Review of drainage study for MHC Kenworth South Fort Worth project at 5001 South Interstate 35W, by Half Engineering and Consideration of Recommendations.

Re: MHC Kenworth – Flood Study Review #1

C04

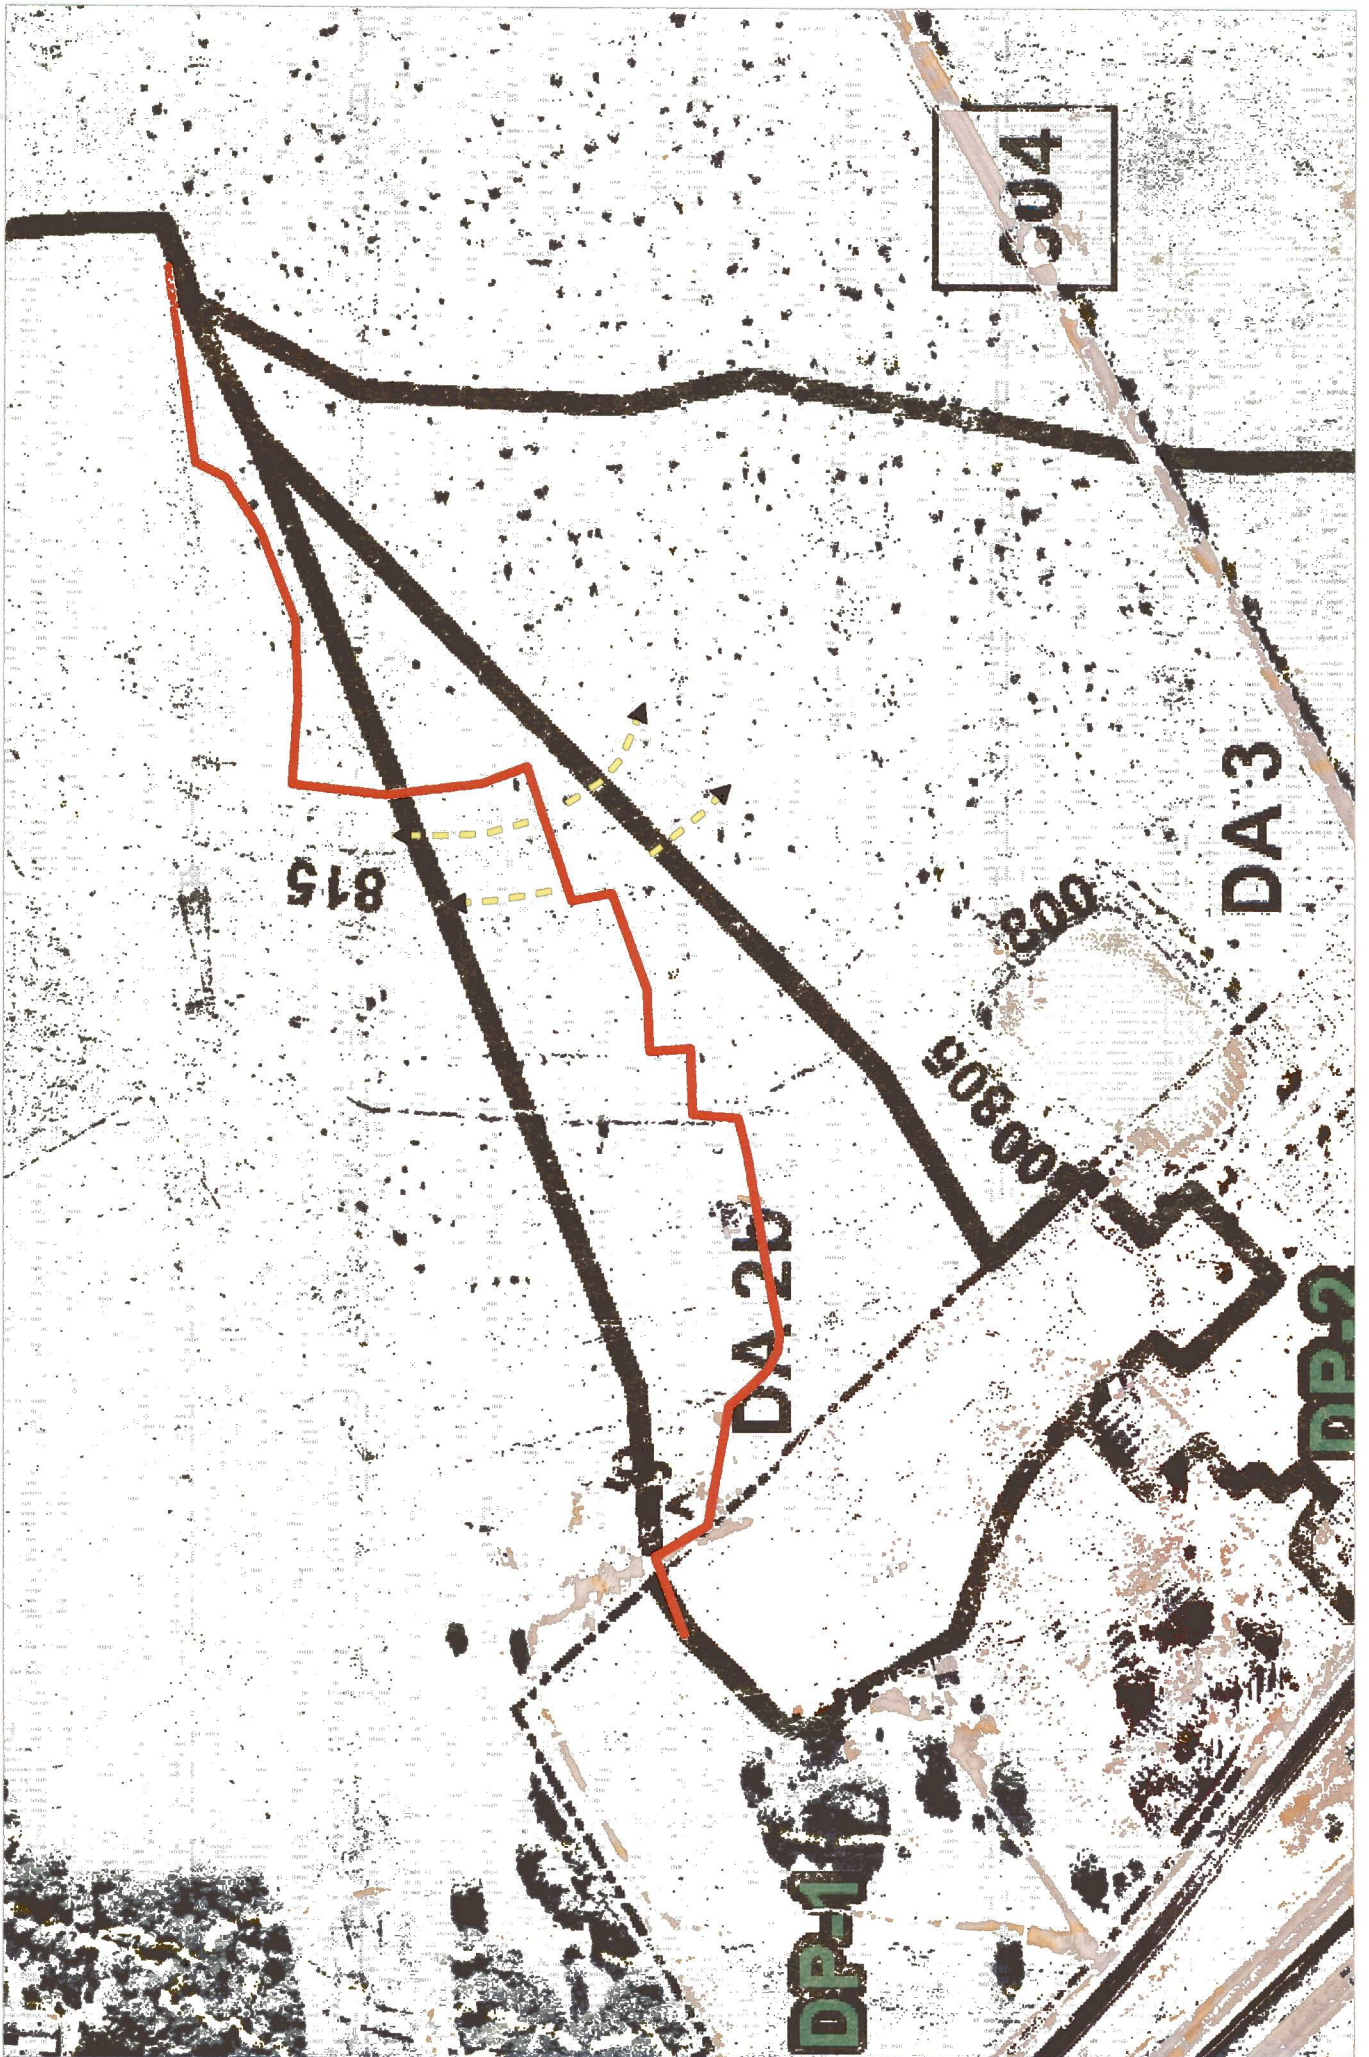
3. Halff reviewed the drainage area delineations based on Johnson County LiDAR. It appears that the size of proposed drainage area DA-2B, which drains to the proposed pond, was significantly overestimated. See attached markups. Please revise the delineations to more accurately reflect topographic data.
